CITY PLANNING COMMISSION

LOCATION: Southwest corner of Garden Highway and Northgate Boulevard

PROPOSAL: The applicant is requesting the necessary entitlements to allow development of approximately 600 self-storage units (60,430 square feet) on proposed Parcel B. and 42,000 square feet of future commercial/business professional facilities on proposed Parcels A and C.

APPLC. NO. P84-357

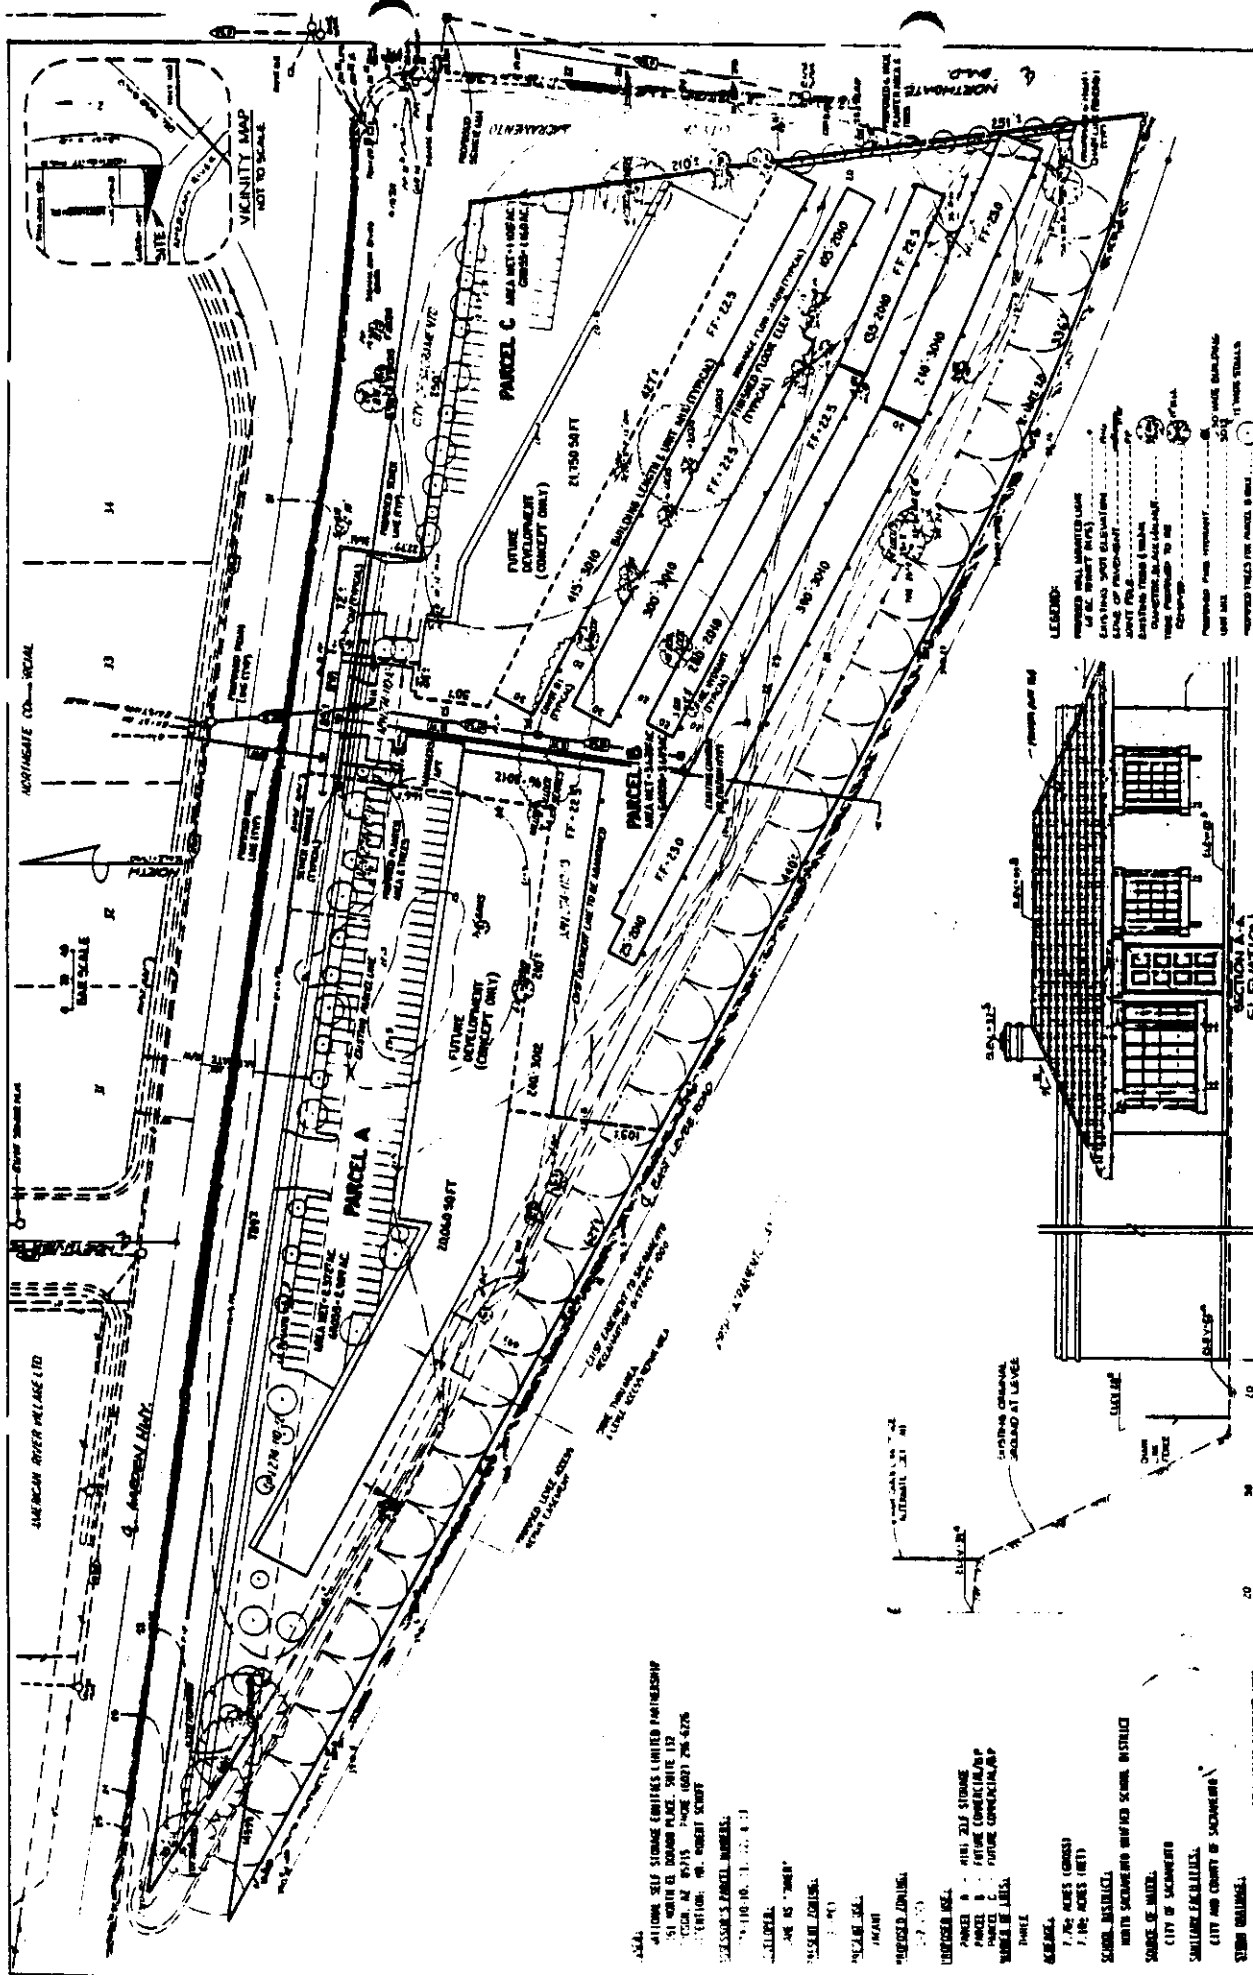
A total of six parking spaces are provided on Parcel B, which is proposed for development at this time. The required parking is seven spaces, based on a ratio of one space per 100 self-storage units, plus one space for the manager's residence. If approval is granted, the applicant should revise the site plans for Parcel B to accommodate one additional parking space for a total of seven.

A total of 44 spaces are provided for parking on Parcel C. Based on a ratio of one space per 400 square feet of office/light commercial, 54 spaces are required. If approval is granted, the applicant should revise the site plans for Parcel C to accommodate ten additional spaces for a total of 54.

A minimum distance of 35 feet between the levee toe and the nearest building is required for development in the Parkway Corridor zone. The southern-most proposed row of self-storage lies within this setback. If approval is granted, the applicant should revise the site plans for

Parcel B to move the southern row of self-storage out of the setback area.

The applicant proposes a six foot chainlink fence adjacent to the levee toe along the southern boundary of the property. This would violate regulations imposed by Reclamation District 1000 restricting development within 10 feet of the levee toe. A six foot chainlink fence or masonry wall along the levee, 10 feet from the levee toe is required by ordinance for development within the Parkway Corridor zone. If approval is granted, the applicant should revise the site plan to include a six foot fence along the southern border, 10 feet from the levee toe.

If the project is approved, staff further recommends an eight foot textured concrete wall as far along Northgate Boulevard as the storage units extend to mitigate visual impacts from the end elevations. This wall should be set back 10 feet from the easement line with 10 feet of landscaping and permanent irrigation between the wall and the street, as required by the Zoning Ordinance. An alternative would be to redesign the easterly building layout to use the building wall as a screening wall.

Development in the Parkway Corridor zone requires a 10 foot tree planting strip adjacent to the landward side of the above-noted six foot fence or wall. This strip is not shown on the applicant's submittals, and it's provision should be a condition of approval should the requested entitlements be granted.

If the project is approved, ordinance requires a minimum 10 foot wide landscape setback along the Northgate Boulevard street frontage. Staff would further recommend that this landscaped strip continue westward from Northgate Boulevard along the property (easement) line to the proposed manager's quarters. Notwithstanding other environmental concerns, all landscaping and irrigation should be installed prior to occupancy of any of the storage units.

The submitted plans do not indicate waste disposal areas. Staff suggests a minimum of two waste disposal areas for the mini-storage facilities. These areas are to be screened by a minimum six foot high solid masonry wall and are to allow for easy access by clients.

The "visible width" of buildings or structures in the Parkway Corridor zone is restricted to a maximum of 250 feet. Each of the four rows of mini-storage proposed by the applicant for Parcel B exceed this maximum width. The applicant should revise the design to conform with this criteria if the project is approved. In addition, the design of the storage units should be compatible with the design and materials of the manager's unit.
